GE Nuclear Energy

April 16, 1996

MFN 050-96
Docket No. 52-001

ABWR Design Change Assessment Review of FOAKE Design Changes

FIGURE 4.6-9 CONTROL ROD DRIVE SYSTEM PFD (Sheet 1 of 1)

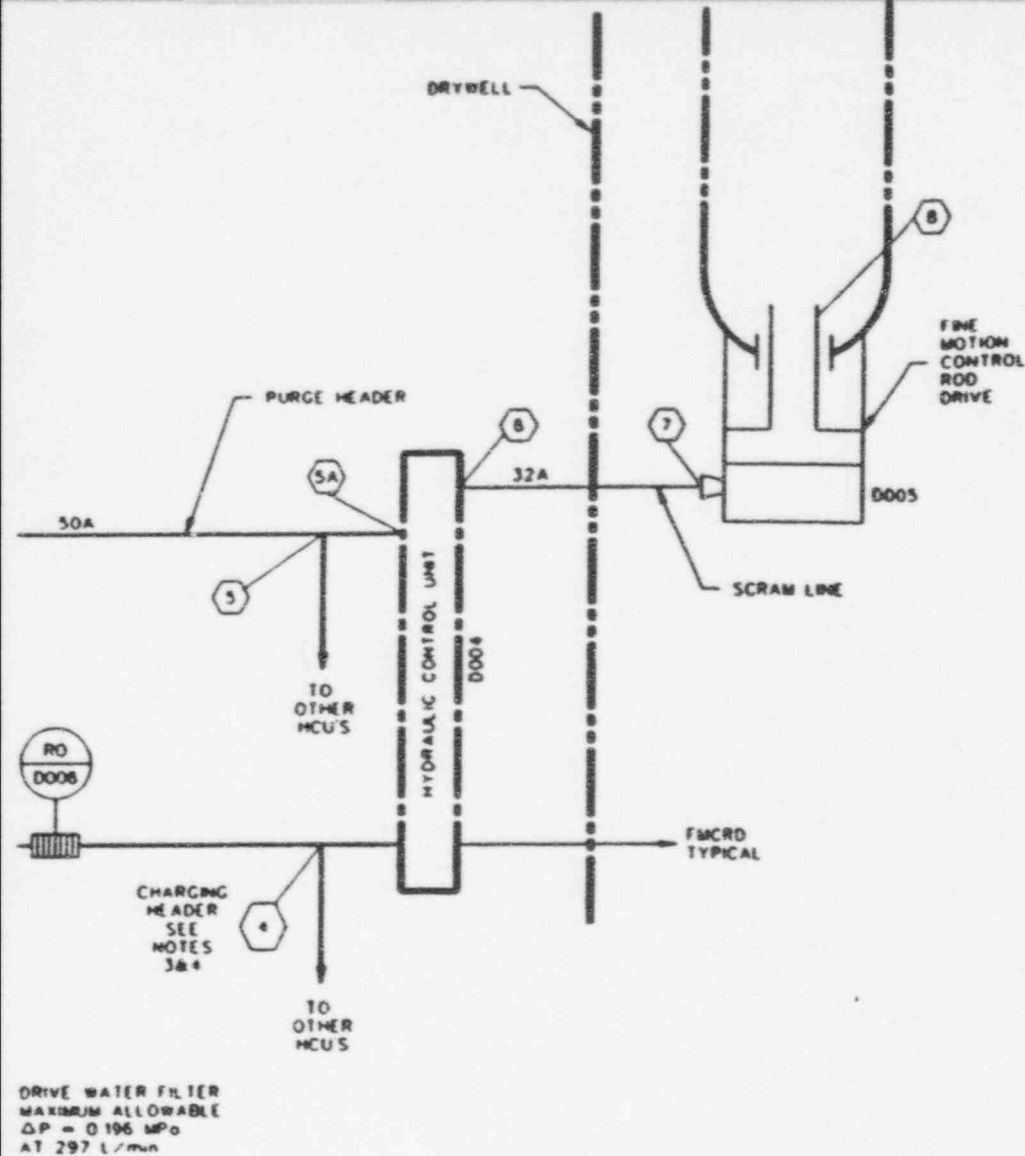
**Increase FMCRD Scram Piping
Design Pressure**

Replace both with "23.5"
